PIC18C658/858

PIC18C658/858 Rev. C3 Silicon/Data Sheet Errata

The PIC18C658/858 parts you have received conform functionally to the Device Data Sheet (DS30475**A**), except for the anomalies described below.

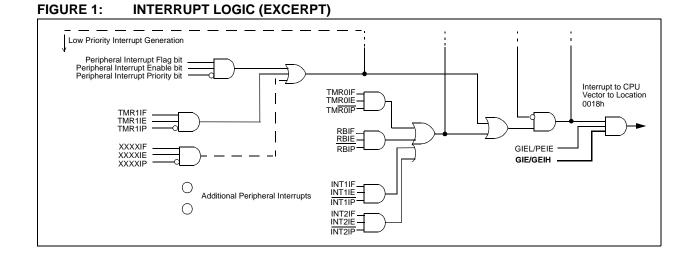
Also, the interrupt logic funnel shown in Figure 7-1 of the Device Data Sheet is amended with the addition of a GIE/GIEH control line, as shown in Figure 1 (new material in **bold line**).

The operation of the GIE/GIEH bit (INTCON<7>) is clarified as follows: when the bit is cleared, all interrupts are disabled. This is regardless of the state of the IPEN bit (RCON<7>), the priority of the interrupt, or whether or not the interrupt is unmasked. This varies from the original description, in which clearing the bit when IPEN = 1 would only disable high priority interrupts.

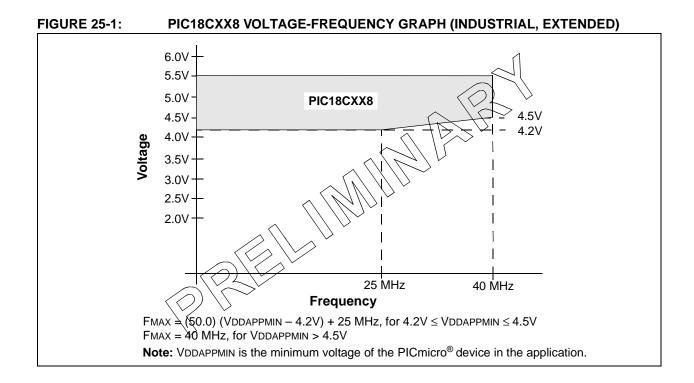
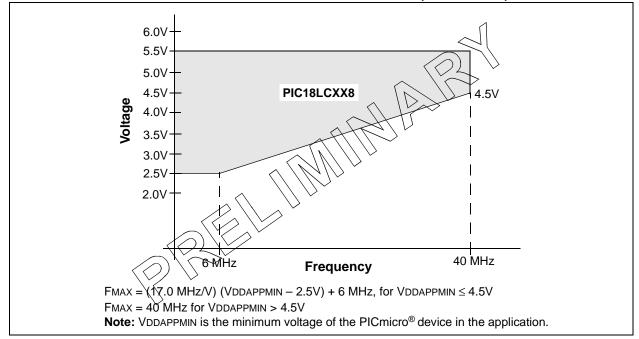
The voltage vs. frequency graphs have also been updated. Figures 25-1 and 25-2 of the Device Data Sheet are replaced with the graphs shown on the following page.

The operating frequency range has been updated.

The maximum frequency for an external clock is clarified as 200 kHz in LP mode, and 4 MHz in XT mode. For all Oscillator modes, parameters 1 and 1A are also clarified as being applicable to both industrial and extended temperature range devices.

The maximum external clock frequency (EC and ECIO modes) and oscillator frequency (HS mode) remains at 40 MHz, as originally reported in the Device Data Sheet (DS30475**A**). Also, the maximum clock and oscillator frequency for HS+PLL mode remains at 10 MHz. This supersedes the more conservative values reported for earlier silicon revisions. Other values of the related clock period parameters are updated accordingly.
